CERTIFICATE OF APPROPRIATENESS

Property: 410 Main Street, Tract 3, Block 44, SSBB Neighborhood Subdivision. The property includes a historic 3,960 square foot, two-story brick front commercial structure situated on a 2,036 square foot interior lot.

Proposal: Alteration – Awning or Canopy

The applicant proposes to add a new canopy and balcony and restore the historic façade as part of the Main Street beautification project.

SOUTH (FRONT) ELEVATION

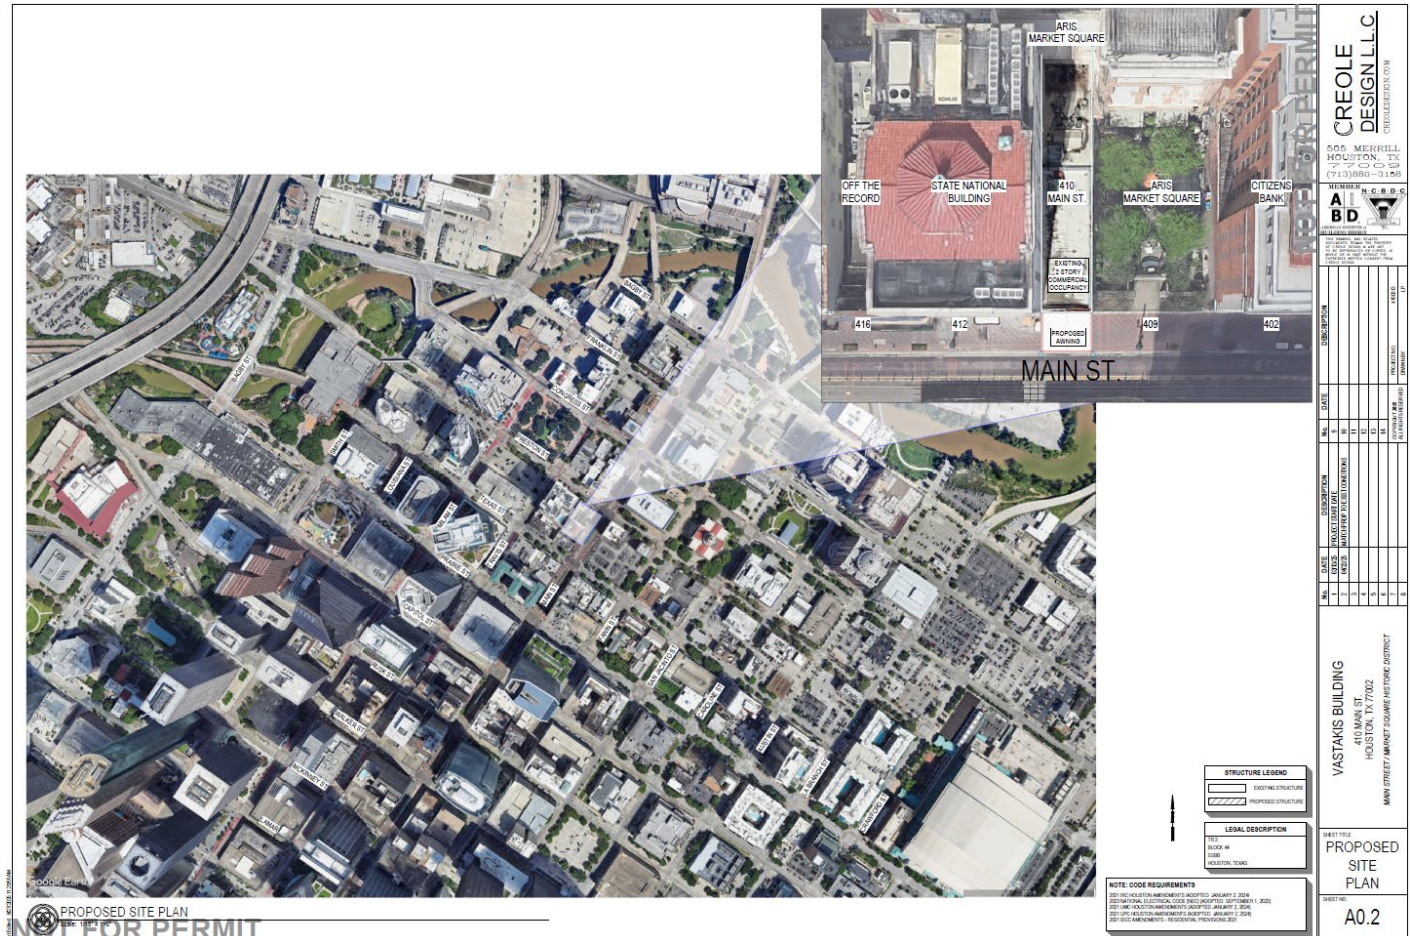
Recommendation: Approval with conditions: 1. Transoms need to be included in the design; 2. Balcony to be as wide as canopy shown on Sanborn; 3. Remove vertical and horizontal joints on second floor facade; and 4. Simplify the storefront per historic documentation.
